# Warragul and Drouin Precinct Structure Plans Review

2021

This section identifies and document amendments required to plans in both PSPs.

## Plan 2 – Future Urban Structure

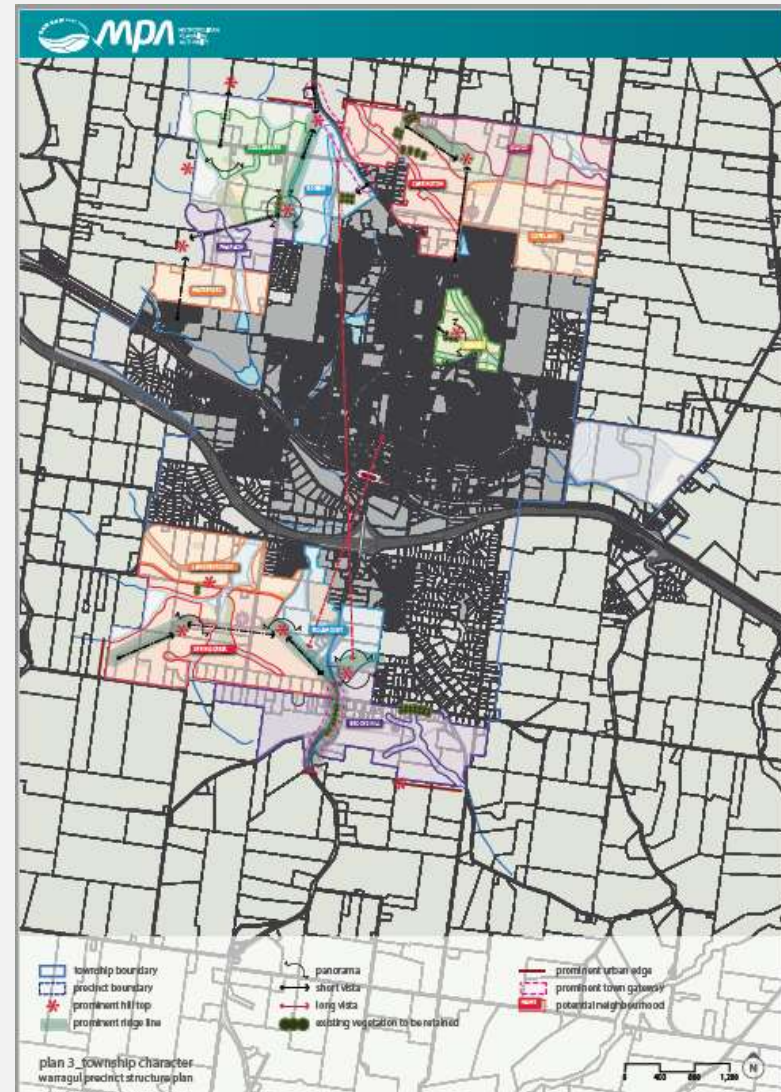
- Update the Plan to show the new locations for the Government Primary School, any other schools, and the Community Facility (south of the Lillico Sporting Reserve SR-02)
- Amend the Plan to show the existing network of local active and passive recreational reserves and potential new linkages that could be developed

## Plan 3 – Township Character

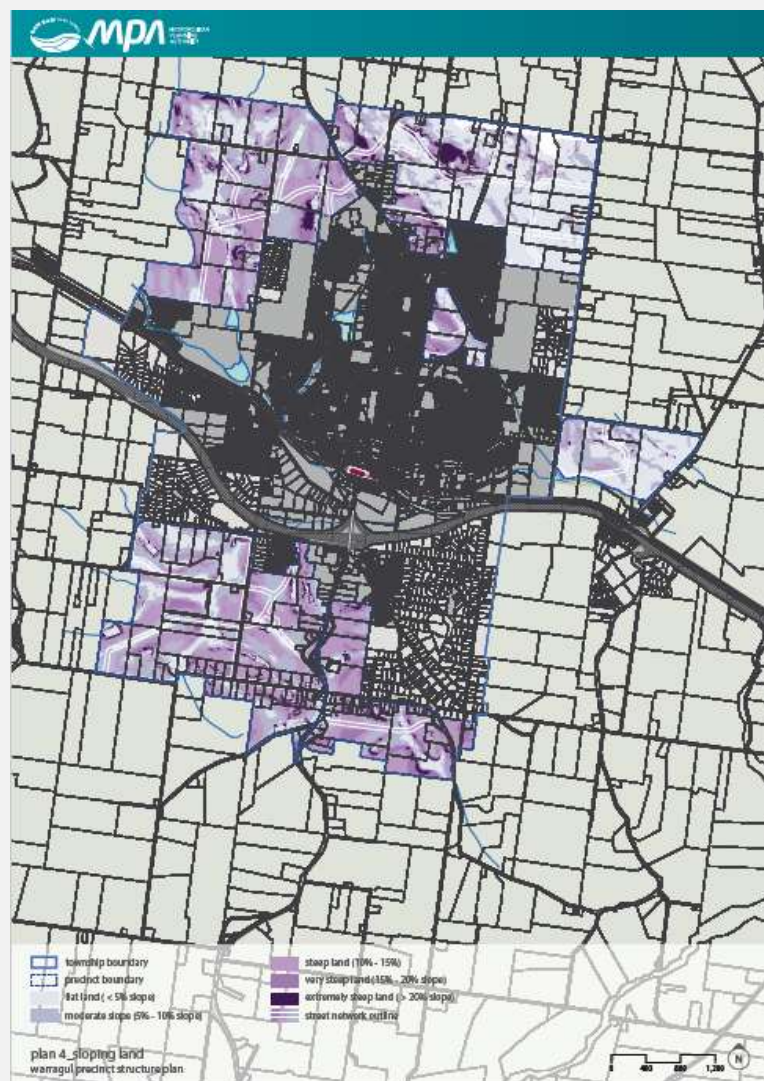
- The plan needs to provide details of vistas to be protected or created (e.g. view of a scenic landscape, a hilltop, other natural features or a prominent structure etc.)
- Plan to be amended to show the correct locations of the prominent hilltops, panorama, existing vegetation to be retained, prominent urban edge and prominent town gateways.
- Prominent Urban Edge and Prominent Town Gateway shown on the Plan require design treatments, which are not currently available. Appropriate design treatments to these Prominent Urban Edge and Prominent Town Gateway could be identified by a Gateway Strategy which is recommended to be undertaken. (this is included in 'Further Works Required' section).

Depending on the outcome of the recommended arboricultural review, additional areas may need to be shown as the “existing vegetation to be retained”.

## Plan 5 – Open Space

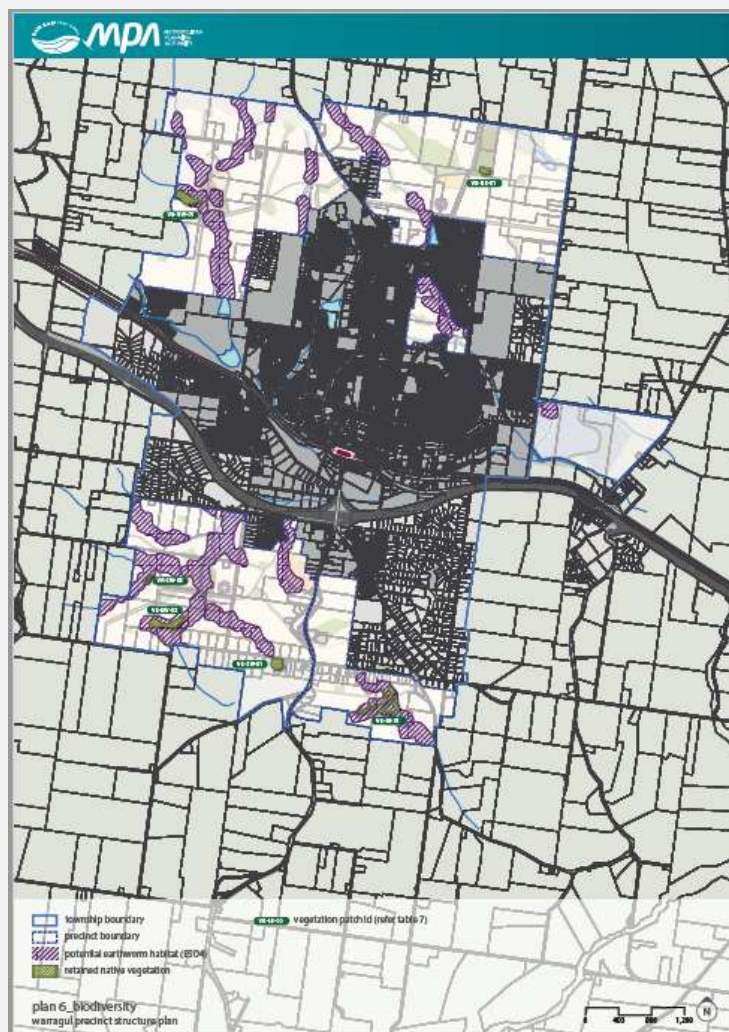
The following locations identified for sporting reserves shown on the plan should be reviewed:

- Location of SR-02 to be reviewed with regards to the steep nature of the land and associated constraints around the northern part of the reserve, and the vegetation patch VR-NE-01 at the southern boundary. These two issues with the identified location limit the useable area for a sporting reserve.

- Location of SR-03 to be reviewed given the steep nature of part of the land; associated drainage issues; and existing vegetation. Additionally, the PSP shows a local street running east-west through the open space dividing it into two parts. An undivided larger open space would be more practical for the identified purpose as a sporting reserve. Open Space NP-NE-O1 (Lillico Road Volcano Park) is located over three properties and may require a masterplan for the overall development of the open space. A masterplan will guide a comprehensive approach to development of the open space even when individual parcels of land are developed at different times.

## Plan 6 – Biodiversity

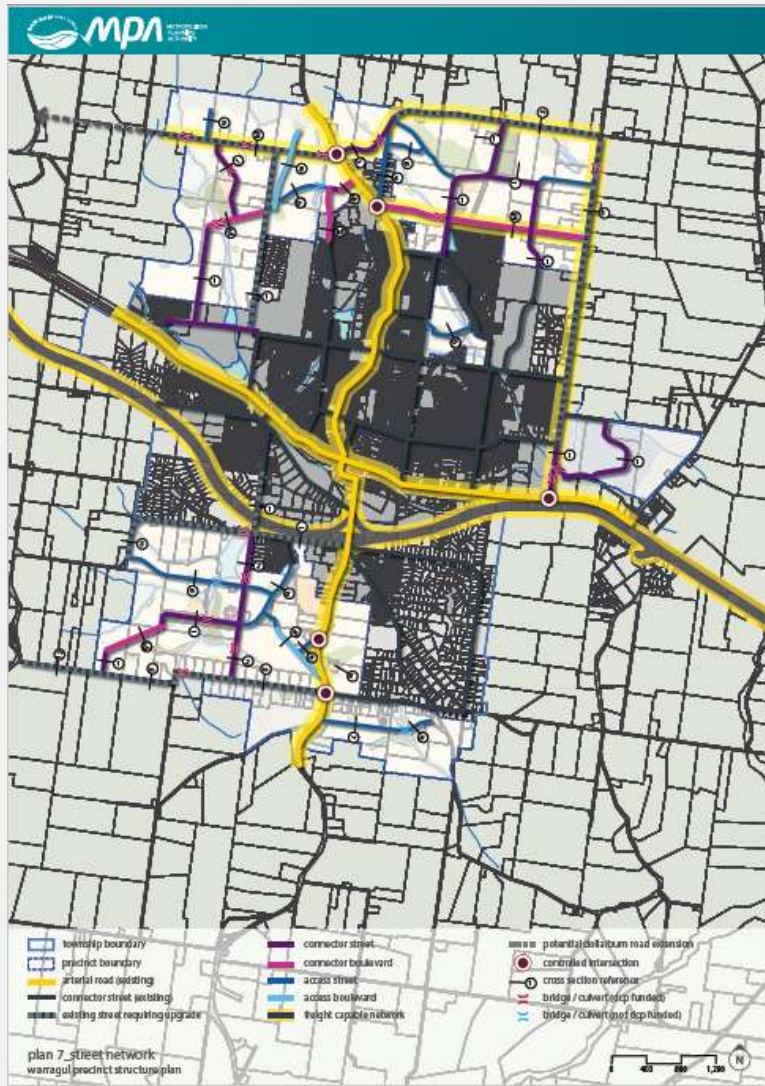
- The Plan refers to Environmental Significance Overlay Schedule 4 (ESO4 that provides protection for potential earthworm habitat. Amendment C108 that introduced Urban Growth Zone into Baw Baw Planning Scheme among other things removed ESO4 from UGZ areas. Reference to ESO4 in the plan is incorrect and should be removed. Similar correction is required to respective Requirement R29 within the Warragul PSP.

- In the absence of ESO4, more emphasis on the Plan and in Requirement 29 is required to ensure needed protection for the Gippsland Giant Earthworm. The legend to the plan currently reading '*Potential Earthworm habitat (ESO4)*' to be amended to read '*Potential Earthworm habitat (to be protected)*'

- Potential areas of Warragul Burrowing Crayfish are not shown on the Plan. Requirement 30 of the Warragul PSP requires that "*Development applications for land covered by natural waterways, drainage lines or seepages must be accompanied by an assessment of the potential impact of the development on the habitat of Warragul Burrowing Crayfish (WBC)*". While this provides some protection for WBC, an opportunity to introduce a formal policy for the protection of WBC could be considered (this is included in the 'Further works Required' section).

- All existing vegetation that is to be protected and retained should be shown on the plan.
- An appropriate planning control such as a Vegetation Protection Overlay is required to protect the identified vegetation. Due to lack of controls valuable vegetation has already been lost in some areas.

- Other plans in Warragul PSP and Plans and concept designs in Warragul DCP should consider and respect significant vegetation identified to be protected in this plan to avoid overlaps.

## Plan 7 – Street Networks

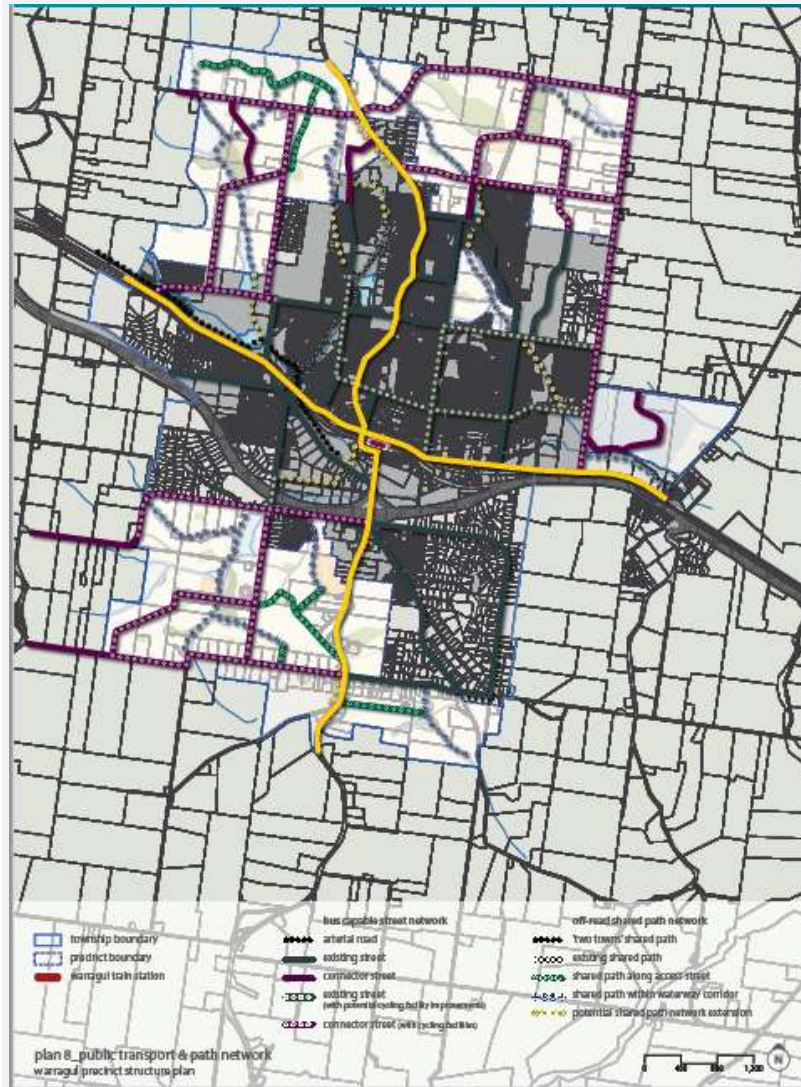
- Amend the plan to show 'Freight Capable Network' as indicated in the legend to the plan
- On completion of the current Review of the Development Contributions Plans (Schedule 2) include any new projects on the plan (as needed)
- An appropriate new location for the Warragul-Korumburra Road and Murdie Road roundabout is currently being considered (DCP ID INA-SW-01). After the new location is finalised, update the plan to show the new location for the roundabout
- A 'further investigation required' note to be included in brackets to 'Potential Dollarburn Road extension' shown on the legend. Details of this extension and cost should be explored. Until such time this cannot be required or imposed on planning permits, as such the above note is required.

## Plan 8 – Public Transport and Path Network

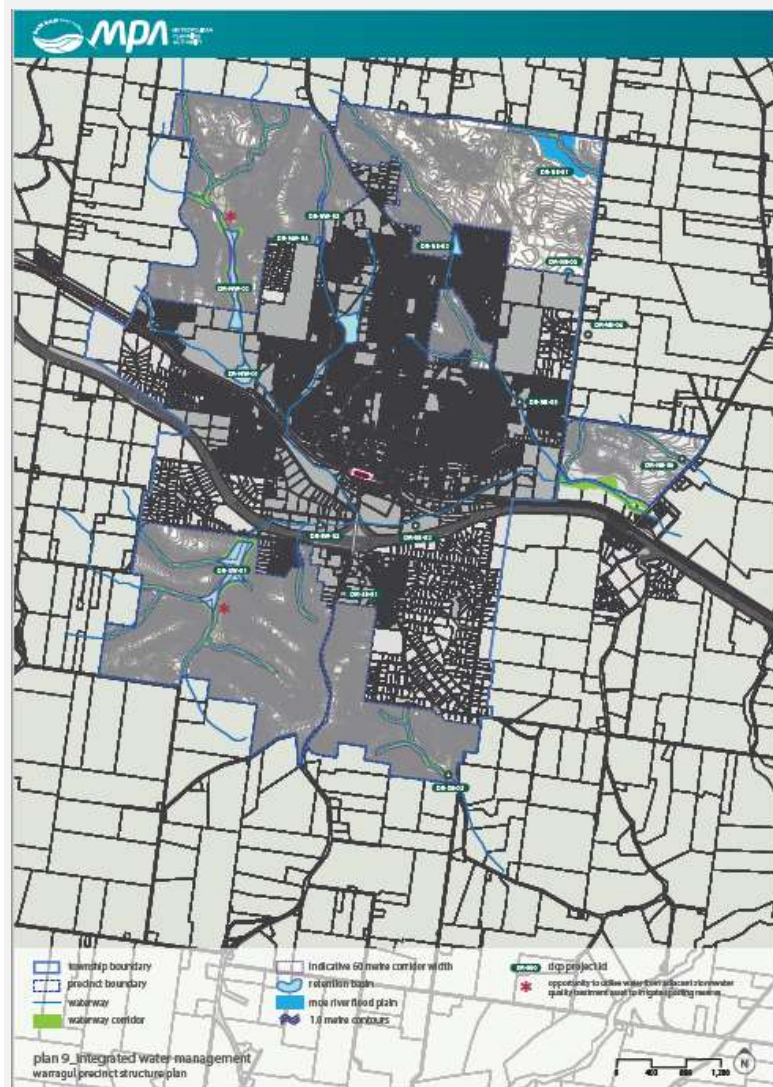
- A 'further investigation required' note to be included in brackets to 'potential shared path network extension' and 'existing street (with potential cycling facility improvements)' both shown on the legend. Details of these projects and cost should be identified. Until such time these cannot be required or imposed on planning permits.

## Plan 10 – Utilities

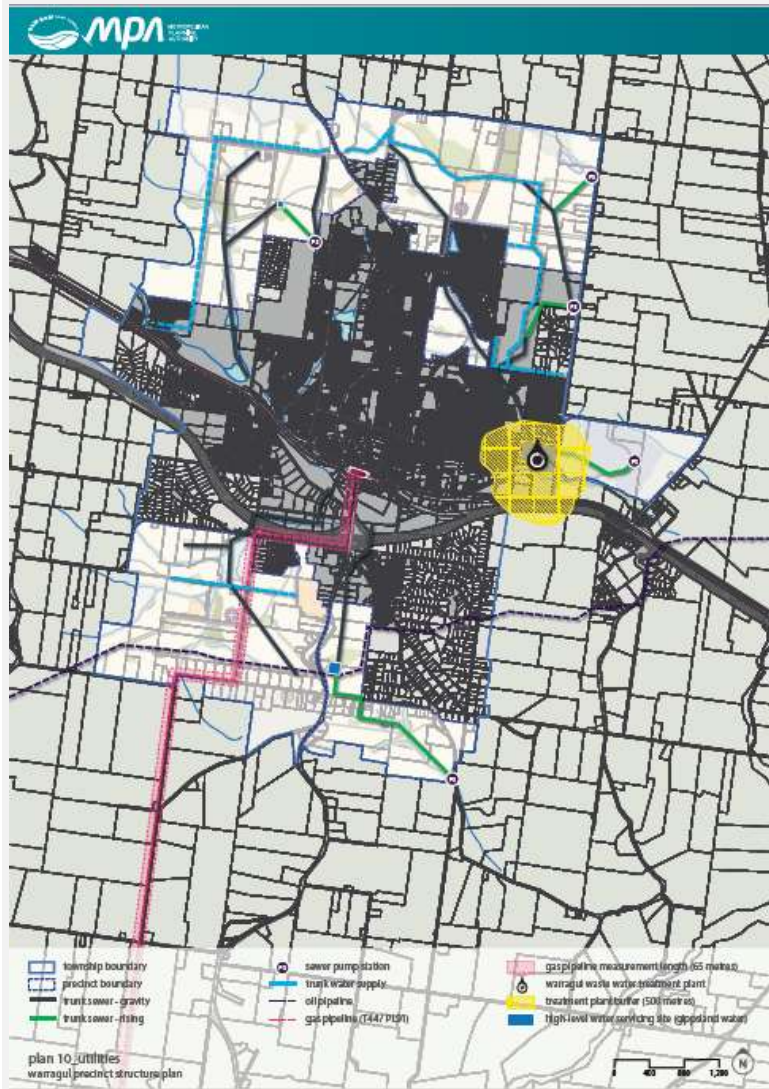
- Amend the plan to show the reduced buffer for the Warragul Wastewater Treatment Plant and the changes to the water and sewer pump stations, trunk sewer and trunk water locations as shown on the plan provided by Gippsland Water in Attachment 1.
- Amend the legend as below:
  - From the current legend “*treatment plant buffer (500 metres)*” to read *Warragul WWTP directional buffer in accordance with EPA Publication 1518: Recommended Separation Distances for Industrial Residual Air Emissions*;
  - From the current legend “*high-level water servicing site (Gippsland water)*” to read *Proposed Drinking Water Basin/Tank*

## Plan 2 – Future Urban Structure

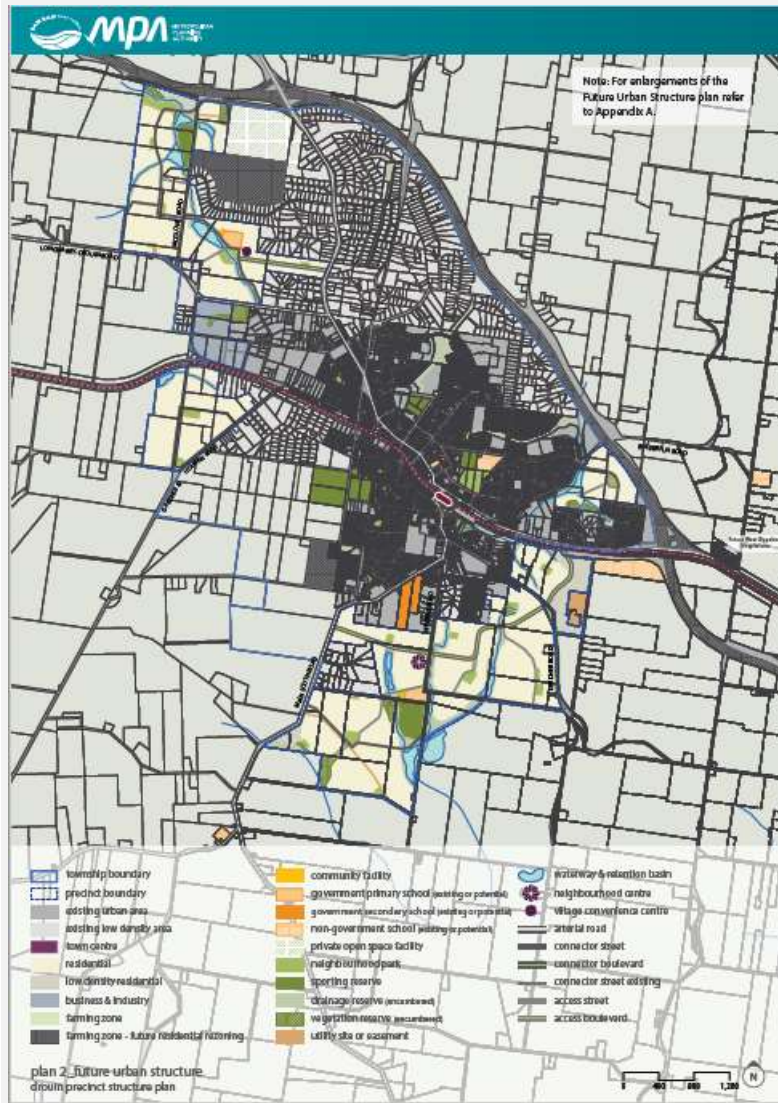
- Update the Plan to show:
  - The new location for the neighbourhood park (small) NP-SE-07 with the two-lot subdivision associated with the new location (to show the boundaries)

- new location for the retardation basin (RB-02) in the North West area along McGlone Road, Drouin
- Amend the Plan to show the existing network of local active and passive recreational reserves and potential new linkages that could be developed

- Correct the reference to the '*non-government school (existing or potential)*' shown in the legend to the Plan to read as '*Existing*' to show the existing Chairo Christian School on this location

- Correct the reference to the following unmade roads on the plan which are currently shown as '*connector street existing*' (refer Attachment 2 for map showing the locations of the unmade roads)

- unmade street from the corner of Golf View Court and Princes Way to the west end of Amberly Drive (north of Shady Close)
- Include additional reference to the Vegetation Reserve (encumbered) VR-SE-05 - (also refer Plan 6) to include *drainage reserve* to the area agreed by Melbourne Water as shown in Attachment 3. This will be consistent with Melbourne Water's Drainage Plan (corresponding changes to be made in Plan 6 and Plan 9)

## Plan 3 – Township Character

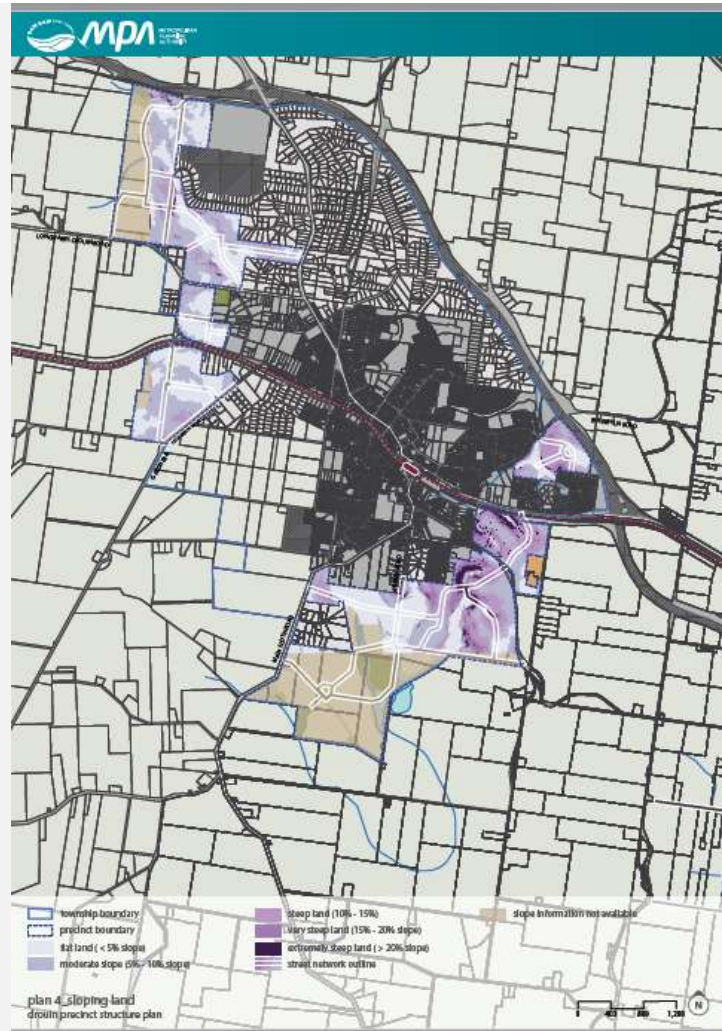
- The plan needs to provide details of vistas to be protected or created (e.g. view of a scenic landscape, a hilltop, other natural features or a prominent structure etc.)
- Plan to be amended to show the correct locations of the prominent hilltops, panorama, existing vegetation to be retained, prominent urban edge and prominent town gateways
- Prominent Urban Edge and Prominent Town Gateway shown on the Plan require design treatments, which are not currently available. Appropriate design treatments to these Prominent Urban Edge and Prominent Town Gateway could be identified by a Gateway Strategy which is recommended to be undertaken.

## Plan 5 – Open Space

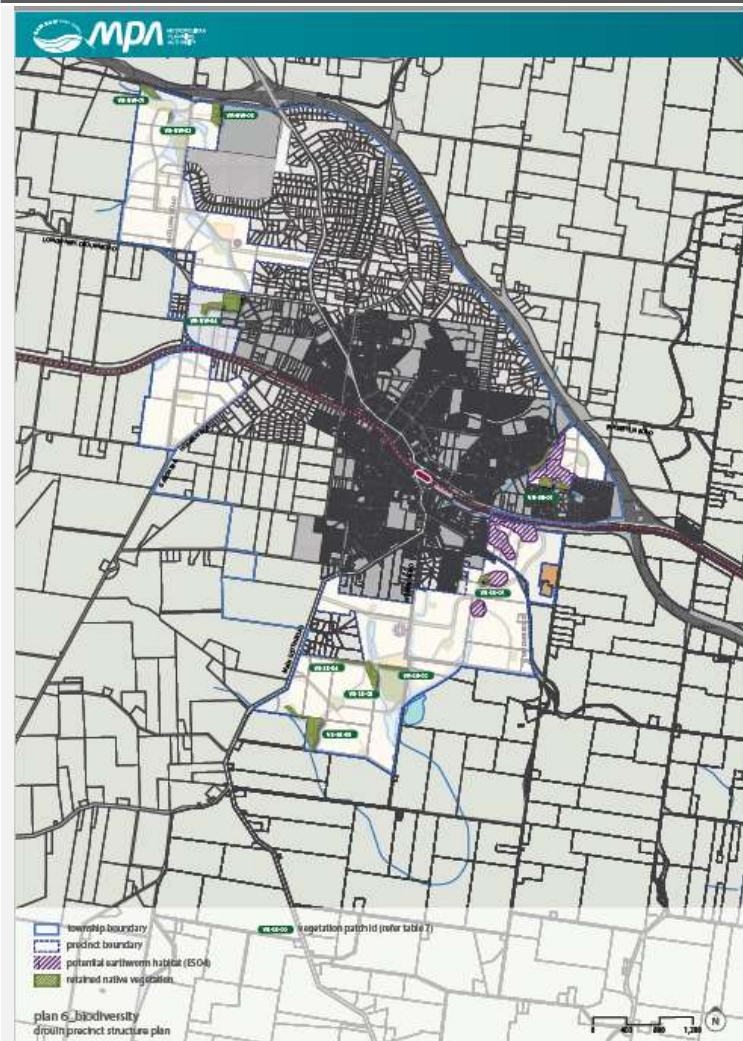
- Update the Plan to move the neighbourhood park NP-SE-05 to its new location (further west towards Main South Road)
